ADDENDUM #1 TO THE TECHNICAL DRAINAGE STUDY

Rainbow and Rancho Multi-family Residential

CLD-22-023

**ADDENDUM #1 to the Technical Drainage Study for Rainbow and Rancho
DS 5674**

Cross Section for X-SEC RAINBOW HALF STREET EX-100 YR

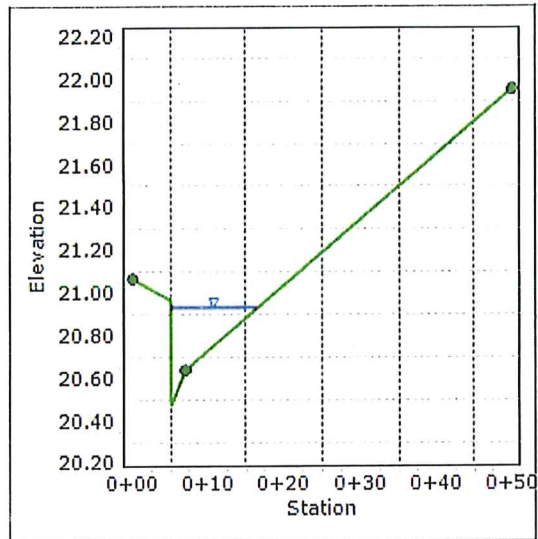
Comment 7: Existing Condition Exhibit: Hydraulic Section X-SEC Rainbow-Half Street-100-yr-Ex shows a depth of 0.4 feet, the depth calculated on the Flowmaster provided is 0.5 feet. Clarify the discrepancy.

The table for Hydraulic Section X-Sec Rainbow- Half Street 100-yr Ex has been updated in the Existing Condition Exhibit to match with the FlowMaster Calculation.

Cross Section for P1-SEC 100 Yr Dev

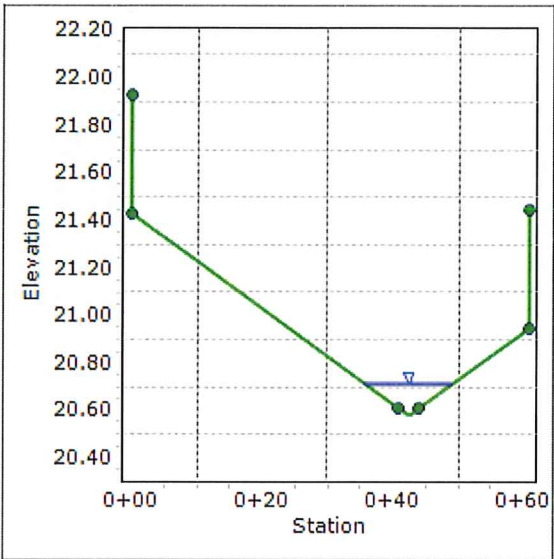
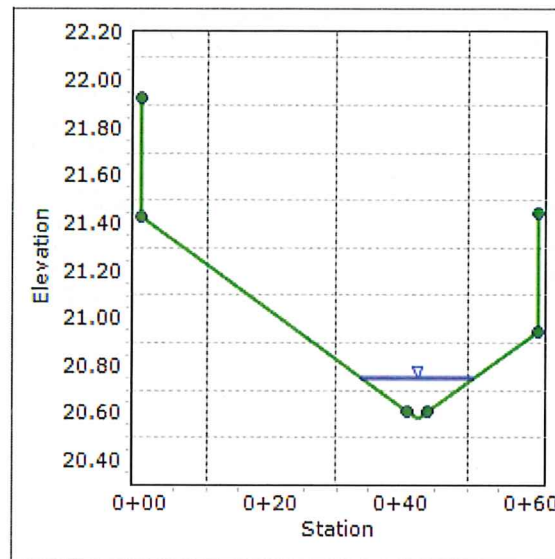
Comment 18: The following finish floors do not meet the Regional Flood Control District minimum criteria of twice the Q_{100} depth of flow up to 18-inches above the water surface (CCRFCD Manual Section 304.4.E.1) or 6-inch minimum above the highest adjacent top of curb (CCRFCD Manual Section 1602 304.4.E.1). The following finish floors should be revised, or alternate flood protection provided.

The developed condition figure has been updated to include additional section P1 and the depth of flow from FlowMaster calculation has been used to check the Finished floor criteria. The submittal includes the FlowMaster calculation for this section. Prorated flow was used to determine the flow depth in the section.

Building	FL Elevation	Depth of flow	Min FF required	Proposed FF _p	Remarks
Garage	2321.90'	0.17'	2322.24'	2322.50'	FF _p >FL+2*DOF
Garage	2321.41	0.17'	2321.75'	2322.00'	FF _p >FL+2*DOF
Clubhouse	2321.03	0.5'	2322.03'	2323.00	FF _p >FL+2*DOF

Worksheet for ES3 DEV-100 YR

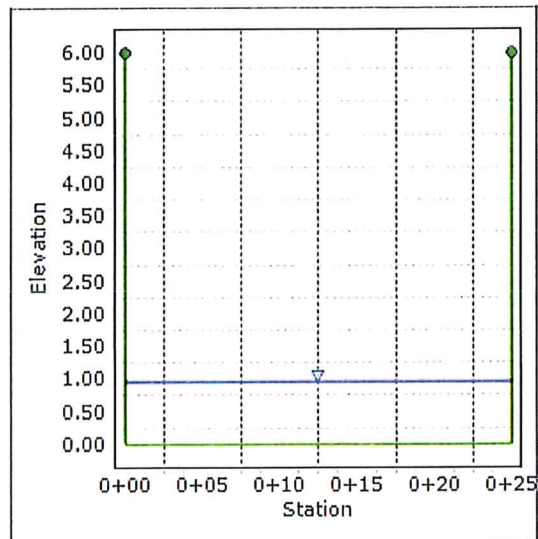
Comment 8: Developed Condition Exhibit: Hydraulic Section ES3 100-yr DEV, the slope shown on the table is 0.4% which does not match the Flowmaster provided showing 0.5%.

The table on Developed Condition Exhibit has been updated with the 0.5% slope to match with the FlowMaster Calculation.

Cross Section for D-SEC -DEV 100 YR

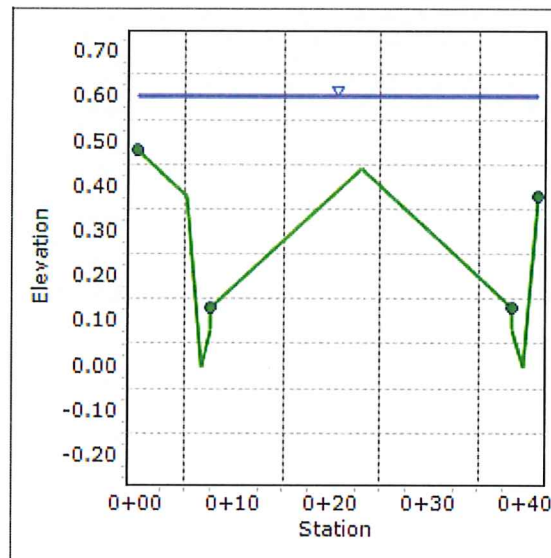
Comment 5: Per the Basin Summary Table, the proposed discharge from the site (DON1) has increased from $Q_{100}=20\text{cfs}$ (XON1) to $Q_{100}=33\text{cfs}$.

It appears that the whole developed site will drain to the southeast corner into the adjacent street Dove Point Place. There are houses adjacent to the south side of Dove Point Place. Address the impact to those houses due to the proposed increase of 100-year flow.

As the proposed discharge from the site (DON1) has increased from $Q_{100}=20\text{ cfs}$ to $Q_{100}=33\text{ cfs}$, the updated runoff of $Q_{100}=33\text{ cfs}$ for the developed condition of onsite basin was used for hydraulic analysis of the downstream street sections and freeboard was found to be sufficient for the increased flow on comparing with the grading plans of Dove Point I & II study.

The D-Sec shows flow depth of 0.6ft on the south side adjacent to our site and the free board provided as per the approved TDS Dove point II is sufficient and meets the finished floor criteria as per CCRFD. The grading plan of approved TDS of Dove Point 2 (GD4, GD5) is attached for the reference.

GRADING PLAN
4 OF 5

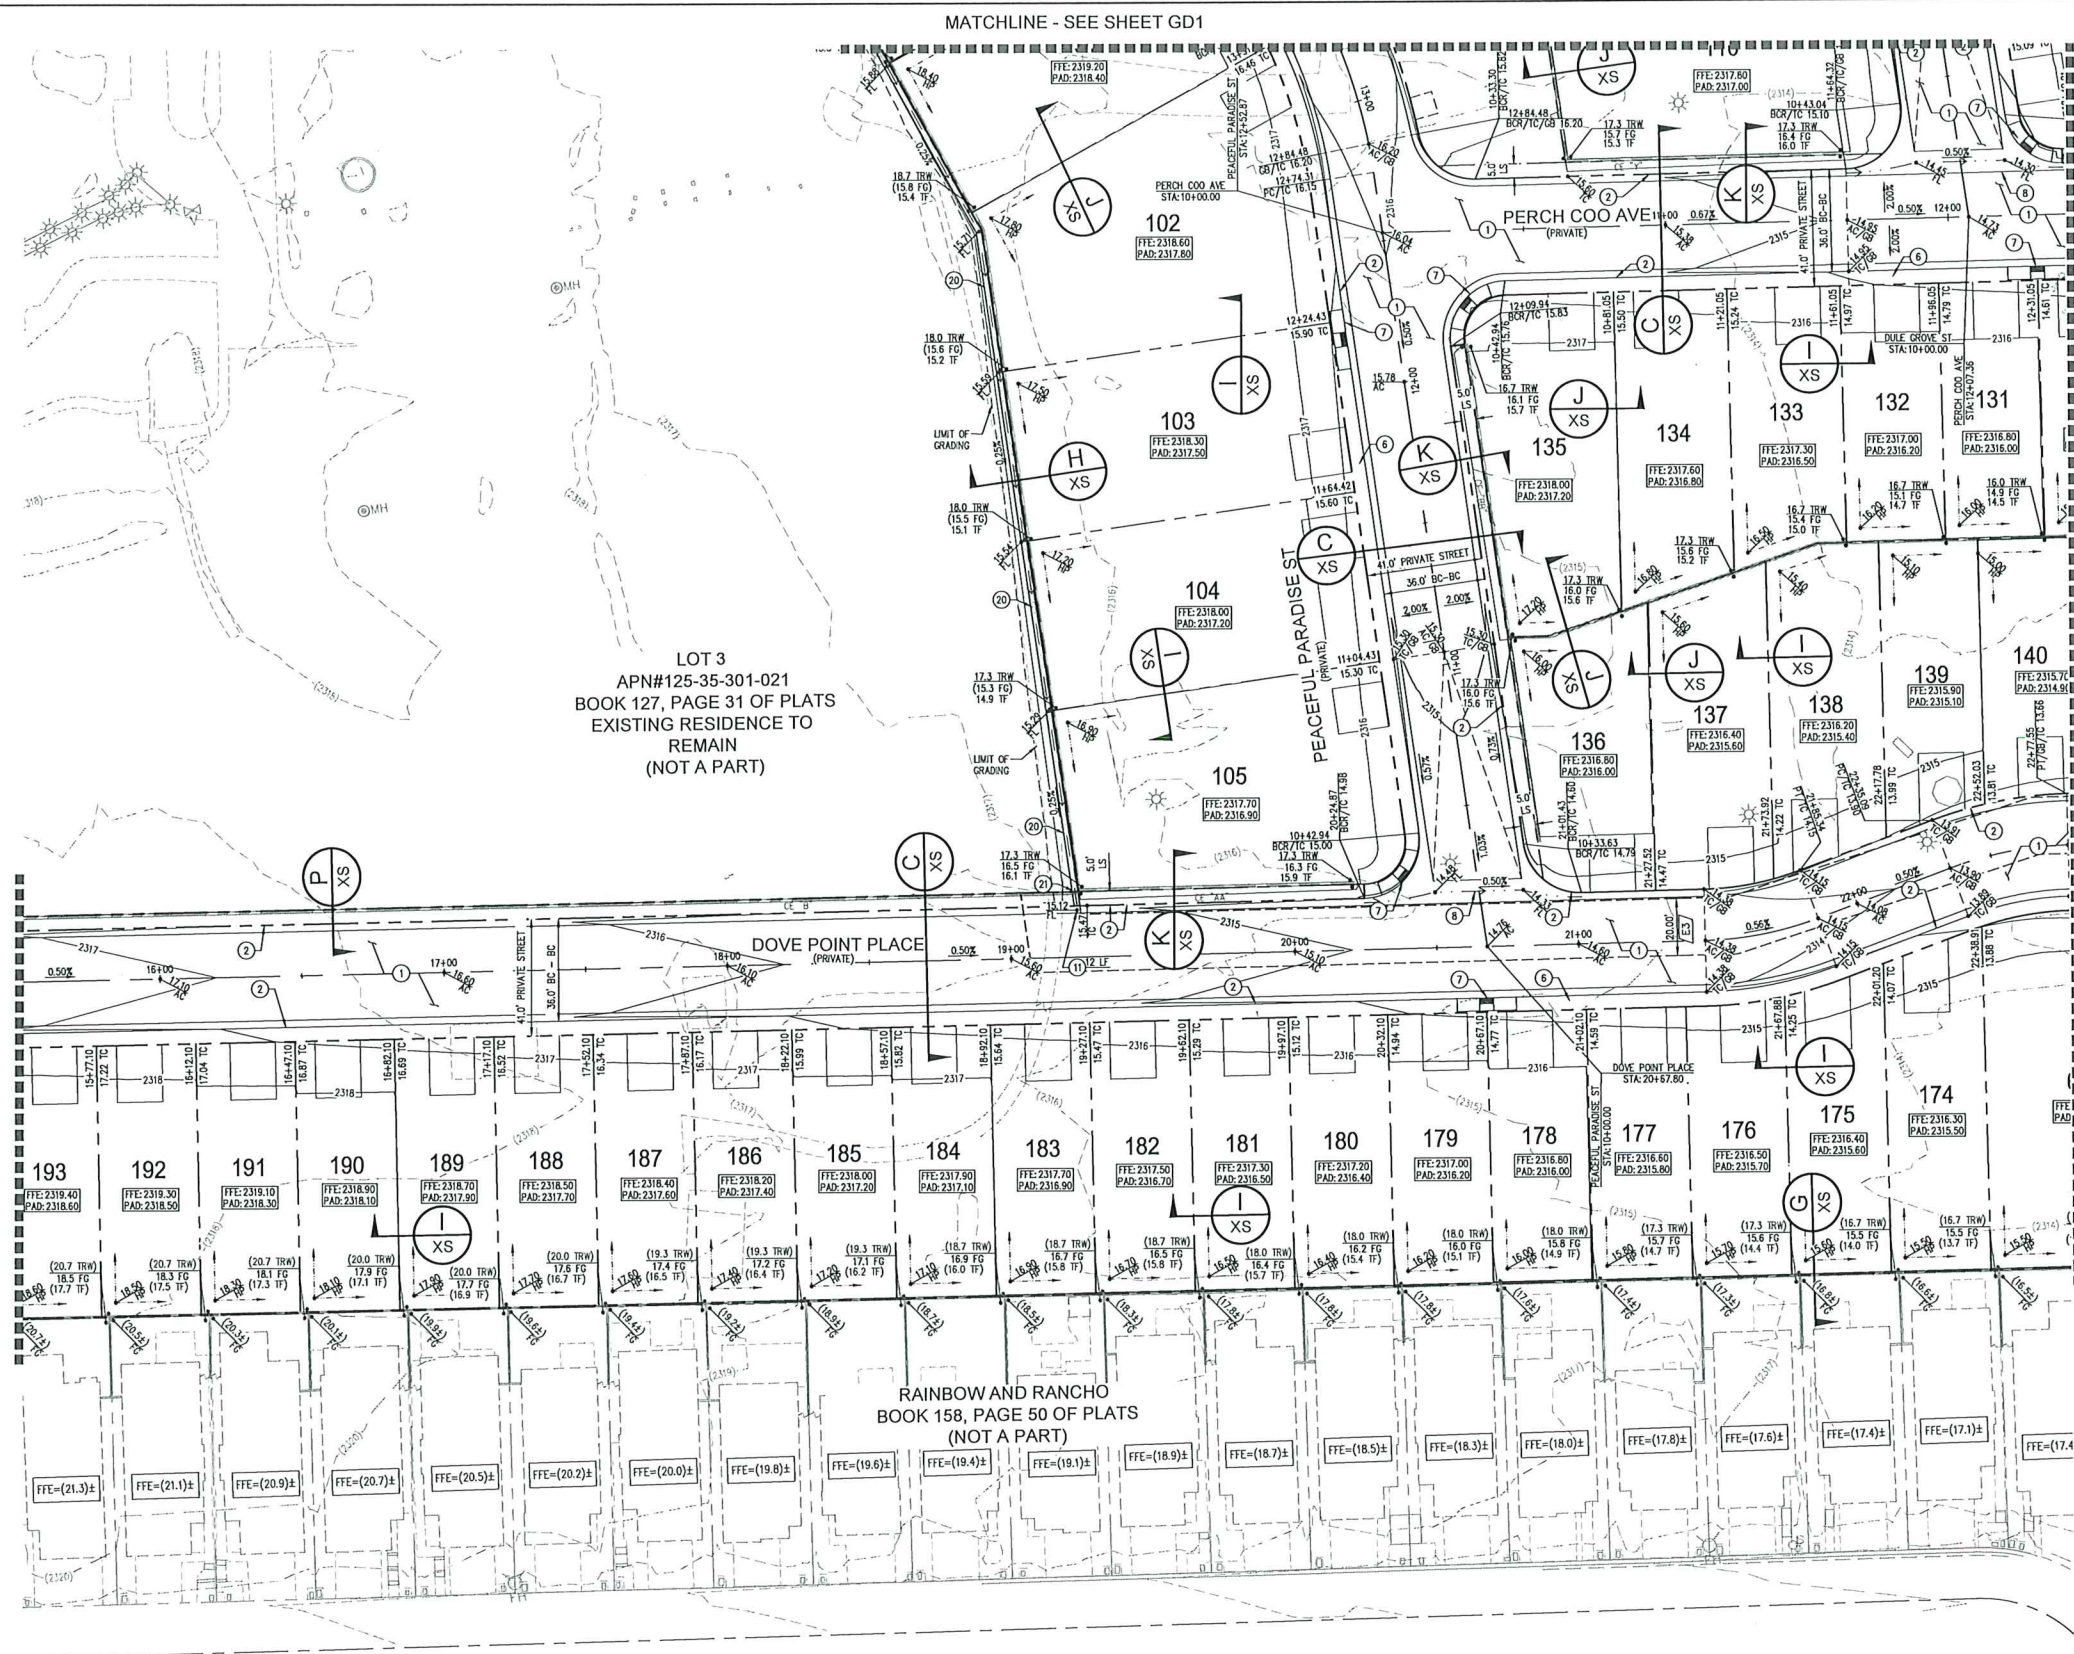
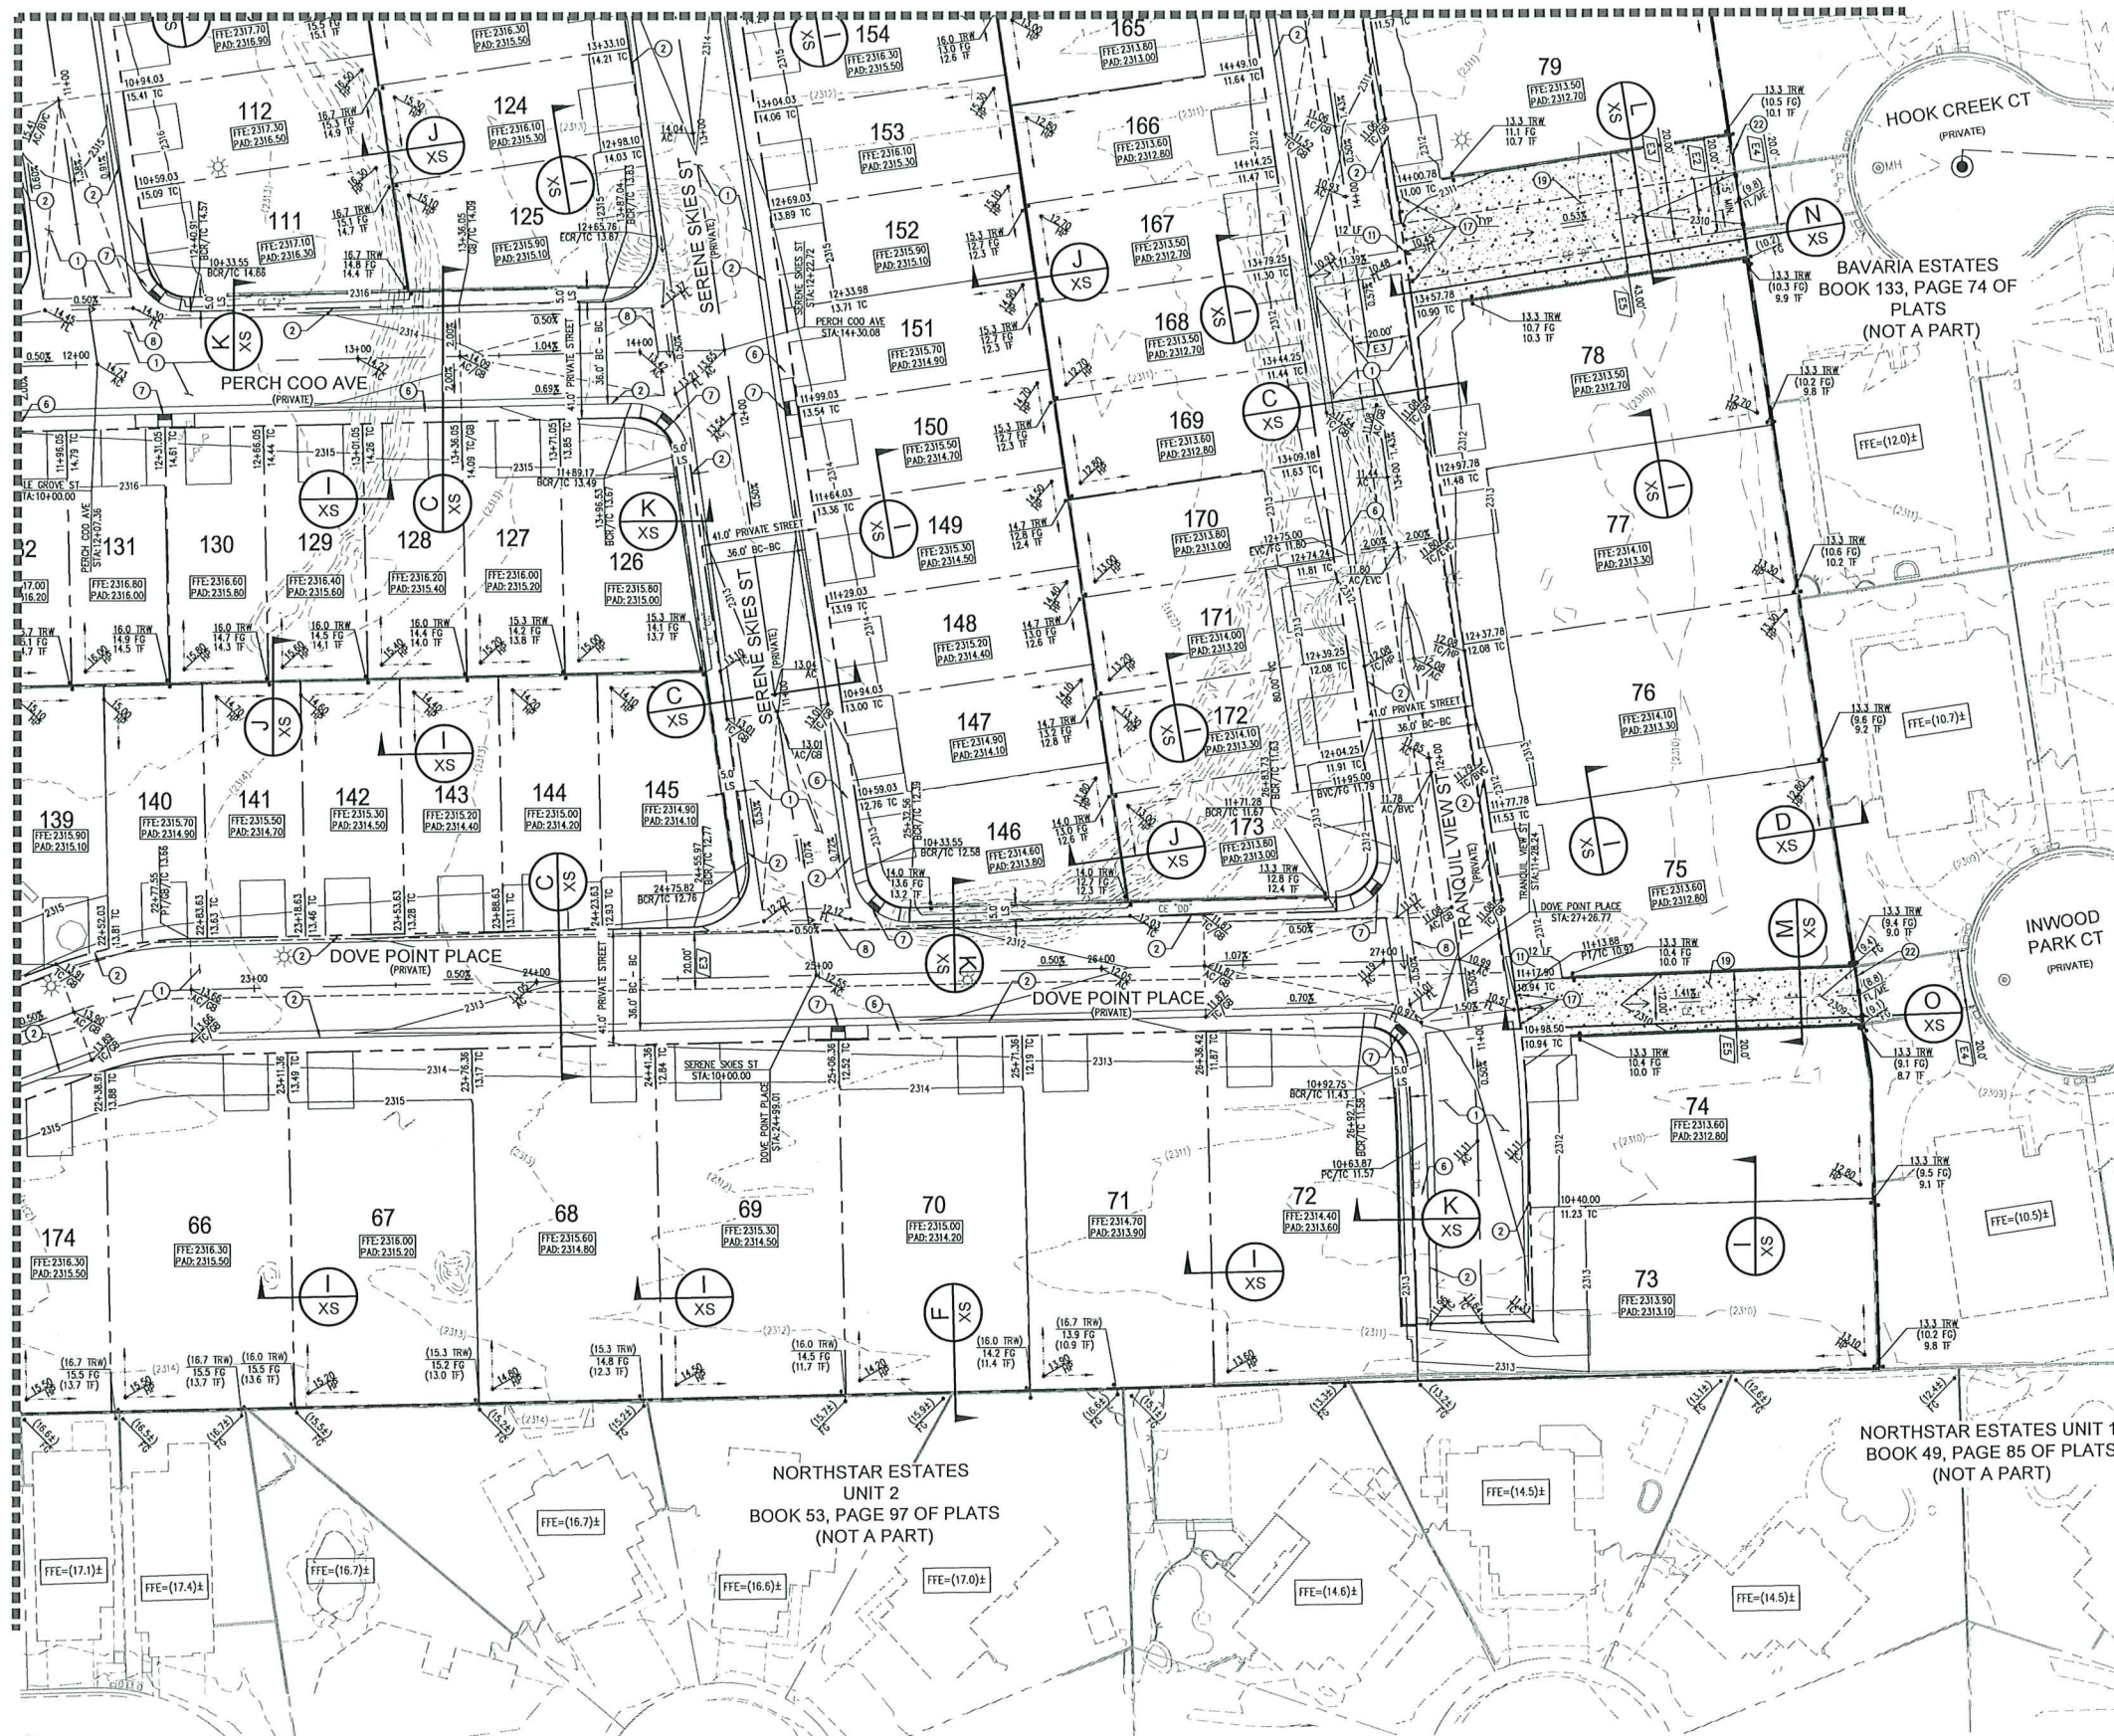
Comment 6: Bavaria Estates is an existing residential development adjacent and downstream of Dove Point I & II. The proposed increase of flow in Dove Point Place will eventually impact a drainage easement in the southern portion of Bavaria Estates. The engineer must address the

approved design flow in the easement in Bavaria Estates in the next submittal. The proposed flow by the subject development shall not negatively impact the downstream properties.

The drainage easement within the southern portion of Bavaria Estates, specifically labeled as ES2 and ES3 in the approved TDS for Dove Point I & II, has been effectively utilized to conduct the FlowMaster Calculation for the downstream sections. This calculation accounts for the increased flow resulting from the proposed subject site. The attached submittal includes the FlowMaster Calculation for these sections, as outlined in the Dove Point Study, and considering the additional flow. It demonstrates that the proposed flow generated by the subject development does not impose any adverse effects on the properties downstream.

The FlowMaster sections have been included with the submittal. The approved grading plan (GD4, GD5) for Dove Point Study is attached for reference.
